Re: **Northwest Self Storage**
Second Completeness Response for CUP-16-01 et al.
Project Number 2150120.01

RESPONSE TO PLANNING DEPARTMENT COMMENTS

RESPONSE TO ENGINEERING DEPARTMENT COMMENTS

Figure 3. Excerpt from Natural Hazards Mitigation Plan Map 16, Landslide Vulnerability Analysis

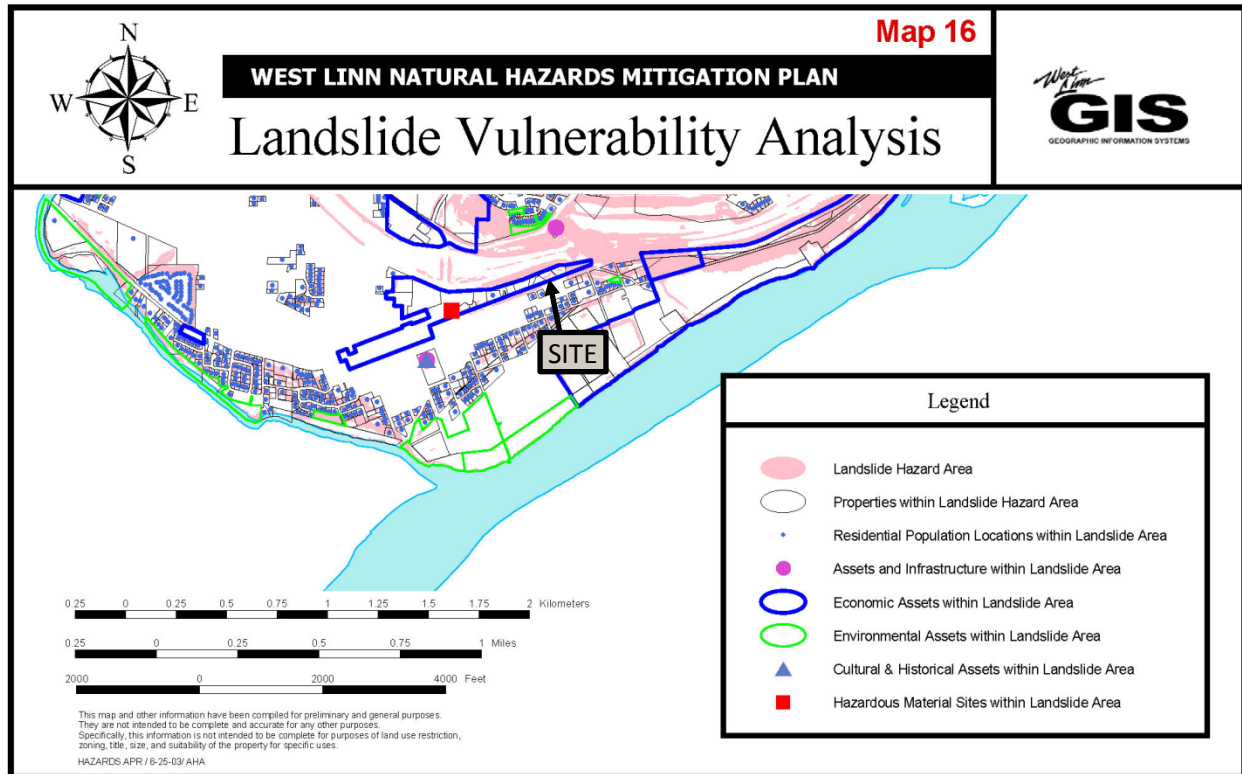
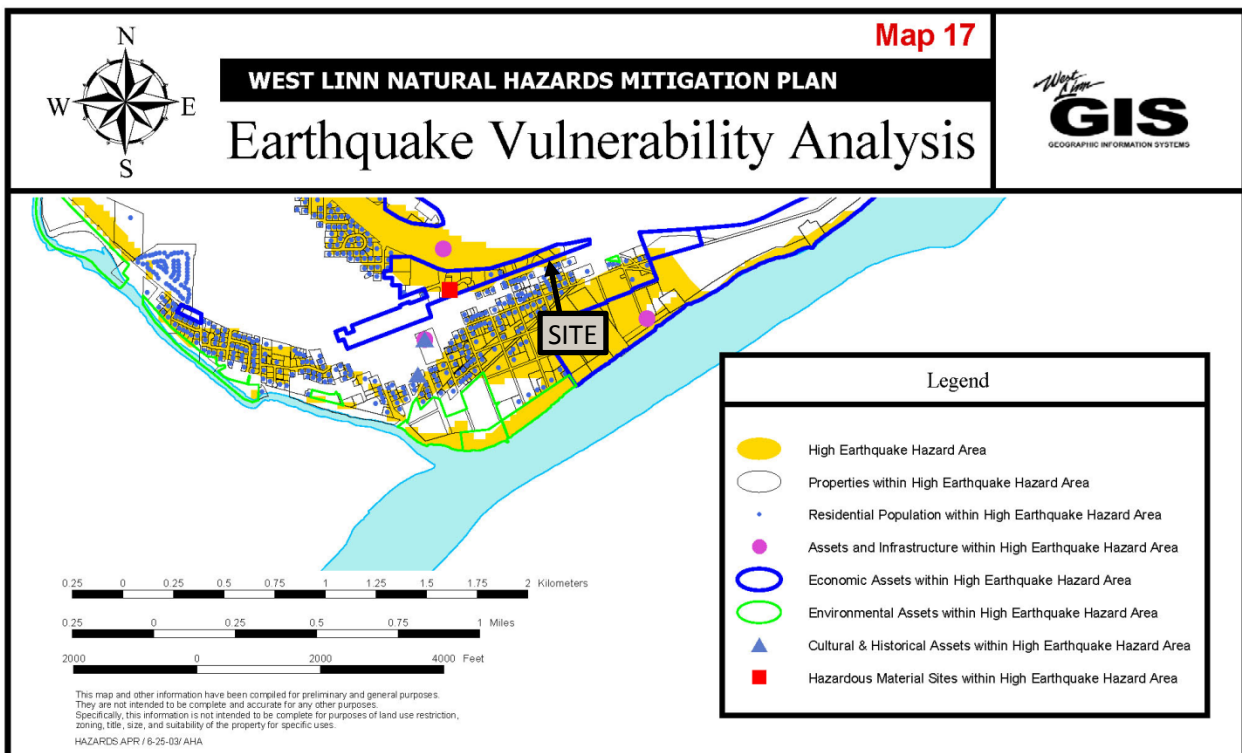
Please provide the mapping as required below. Provide a Geotechnical Engineer's discussion of these maps relative to the site, potential impact on the site and any needed mitigation.

- c. *Landslide areas designated by the Natural Hazard Mitigation Plan, Map 16; and*
- d. *Landslide vulnerable analysis areas, designated by the Natural Hazard Mitigation Plan, Map 17.*

Response: Sheet C1.0 has been updated to include notes discussing the landslide and earthquake vulnerability maps and comparing those maps to on-site topographic data and the site-specific geotechnical investigation. Furthermore, the

narrative has been expanded in sections 28.110, 32.060, 55.100, and 55.110, including excerpts from the referenced maps and pointers to the subject property, to provide additional information with regards to landslide and earthquake risks with reference to the geotechnical report.

The Landslide Vulnerability Analysis Map categorizes slopes over 25% as landslide hazard areas; accordingly, those have been identified on the site analysis plan (Sheet C1.0). These areas primarily correspond to the banks and slopes leading down to Bernert Creek, which will largely remain undisturbed due to the placement of the building as far north as possible to minimize impacts to the water resource area. The site also backs up to the I-205 on-ramp support slope, which has grades well in excess of 25%. However, as this slope is an engineered fill that was constructed under the supervision of ODOT for the highway construction it should present a relatively low landslide risk. The Earthquake Vulnerability Analysis Map identifies the area north of Willamette Falls Drive (including the site) as a high earthquake hazard area. By contrast, the geotechnical report (Exhibit A) indicates that seismic hazards are low at the site. Furthermore, the geotechnical report states that “Based on our analyses, slopes that are inclined, retained, and drained as described herein have suitable stability” and the report contains site-specific recommendations for maintaining slope stability, both during construction itself and for the design of structures. This standard is met.
